**JAVELINA UNIT 613 (613H,
614H, 615H, 509H, 510H)
[fJMB2221553059]**

**C-144/ Permit Approval
with Conditions**

JAVELINA UNIT 613 (613H, 614H, 615H, 509H, 510H) [fJMB2221553059]
Temporary Pit non-low chloride fluids.

NMOCD has reviewed [4323] CHEVRON USA INC, Application and Form C-144 received on July 28, 2022, for the proposed JAVELINA UNIT 613 (613H, 614H, 615H, 509H, 510H) [fJMB2221553059], Temporary Pit in Unit Letters M & D, Sections 11 & 14, Township 24S, Range 31E, Eddy County, New Mexico.

Appendix D – Design Plan**Javelina Unit 613 Pit****Temporary Pit**

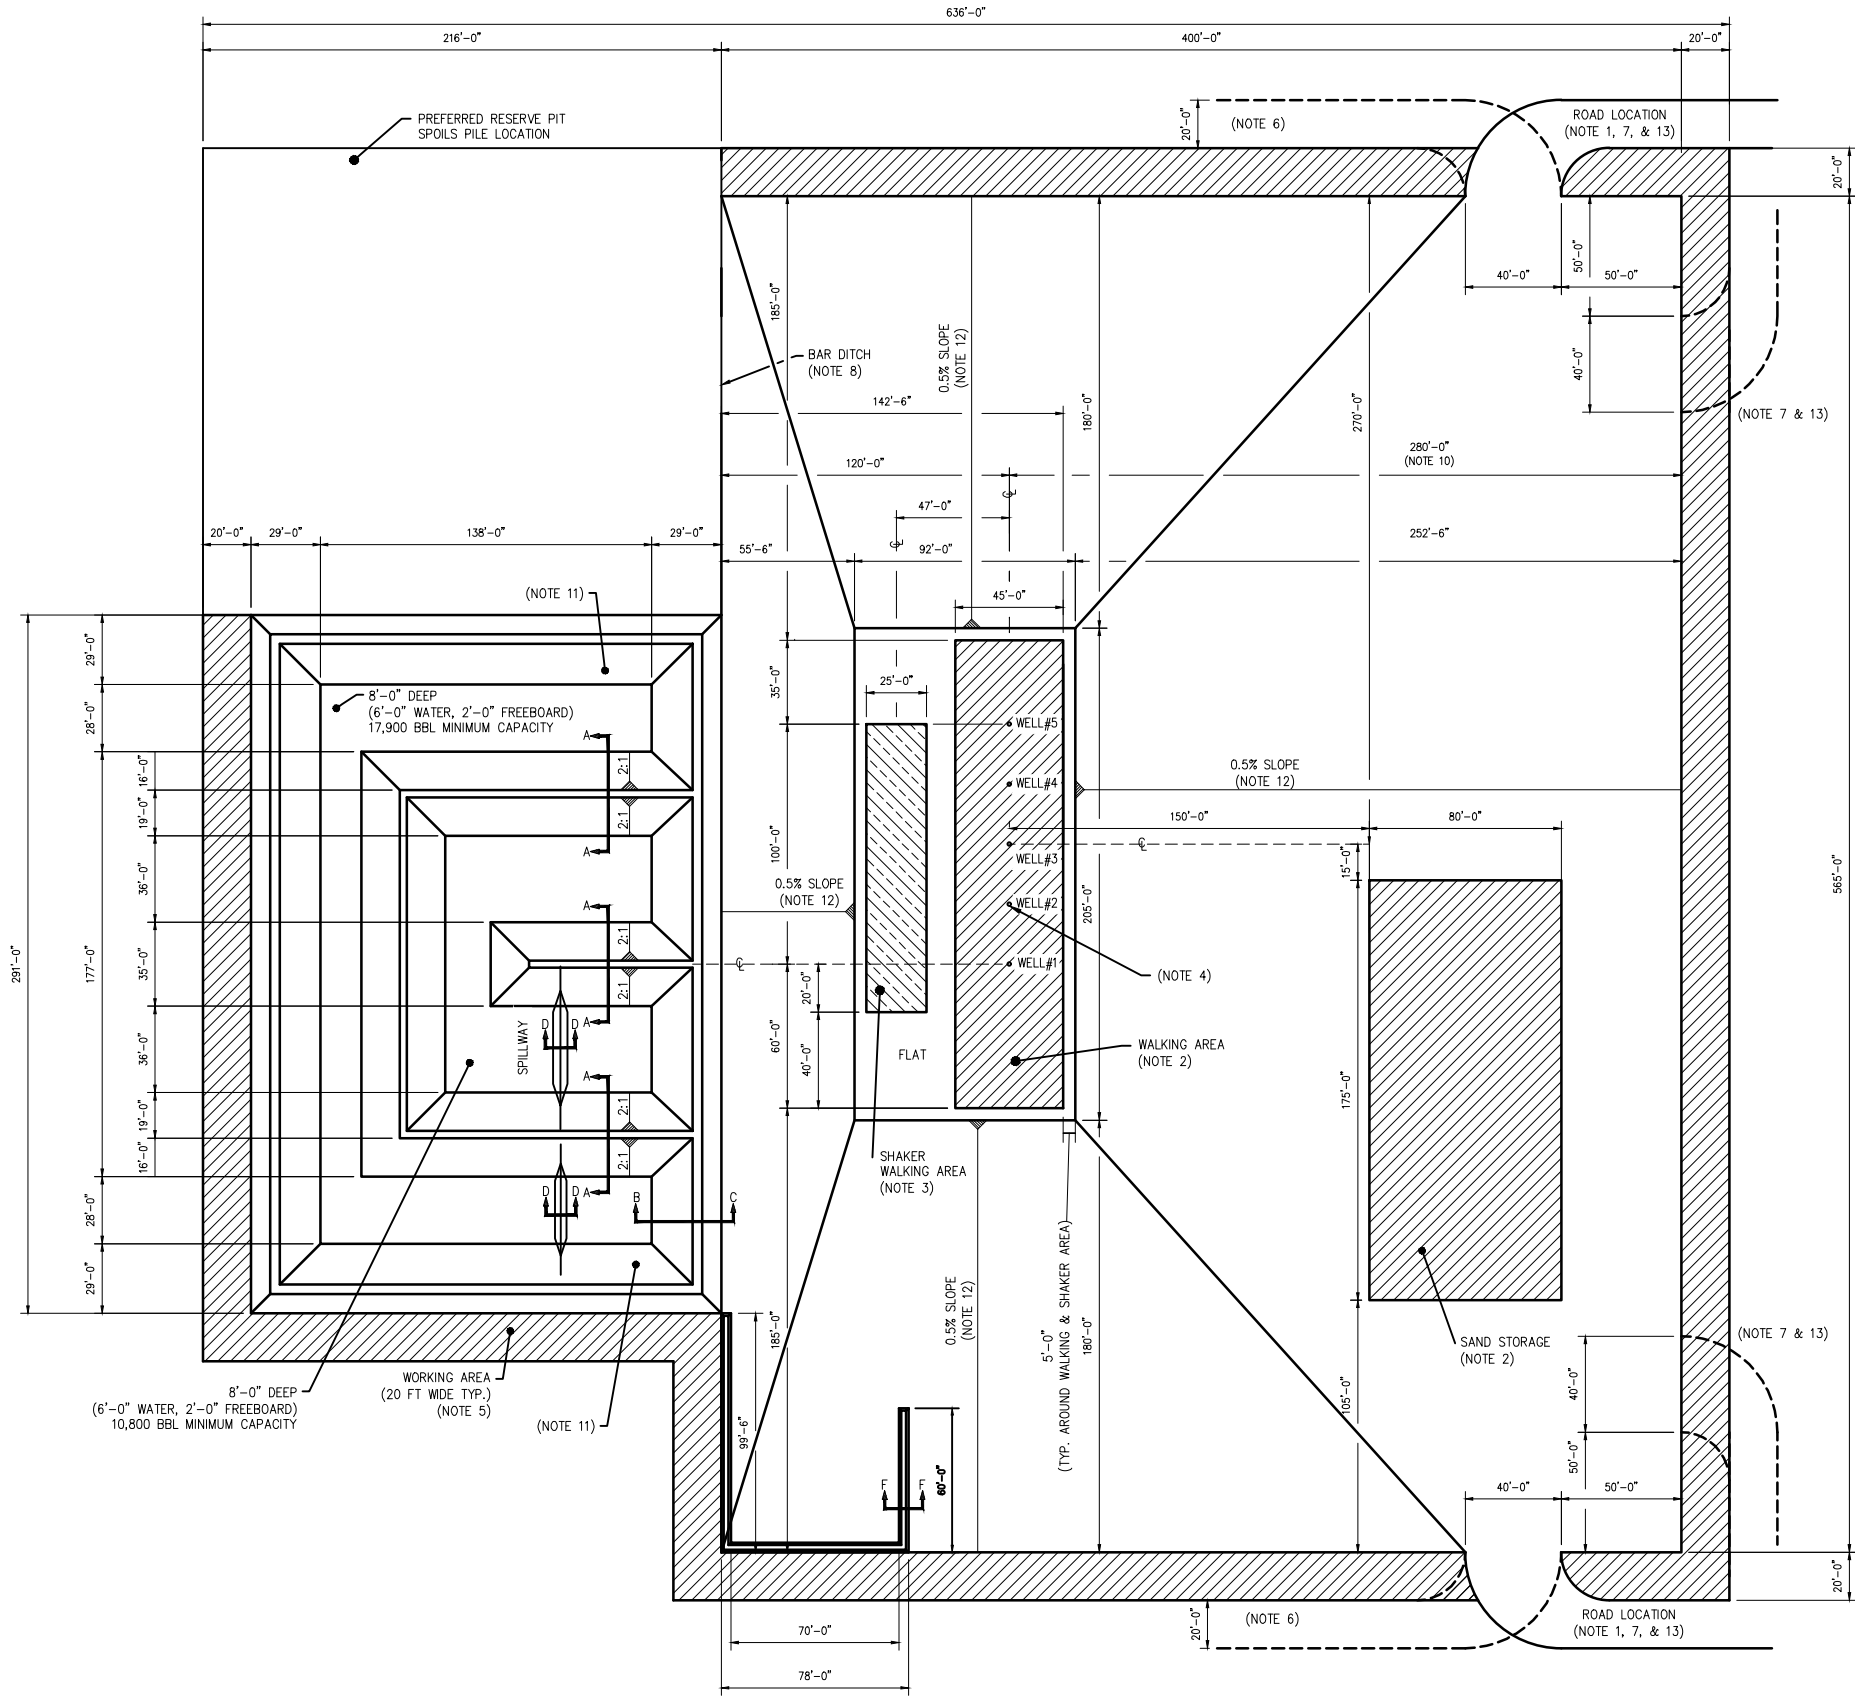
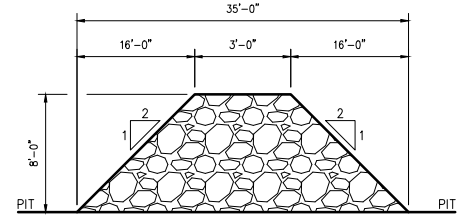
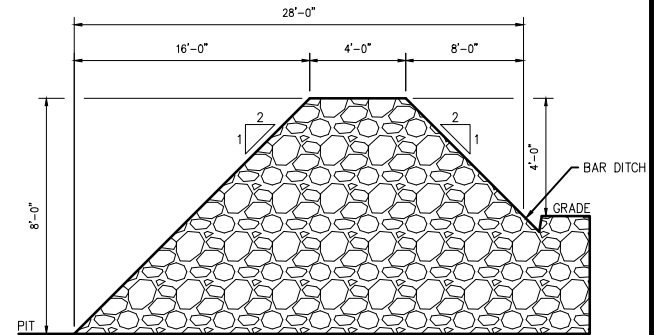
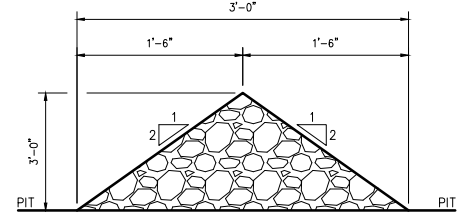
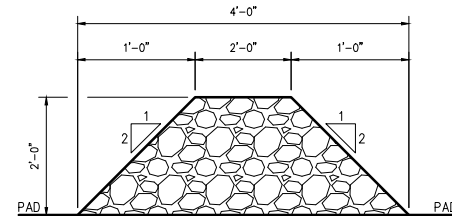
4. The design and construction plan, included as Appendix D of the Application, is approved. [4323] CHEVRON USA INC shall design and construct JAVELINA UNIT 613 (613H, 614H, 615H, 509H, 510H) [fJMB2221553059] Pit as described in the approved plan. [4323] CHEVRON USA INC shall apply for a permit modification for any change to the plan.
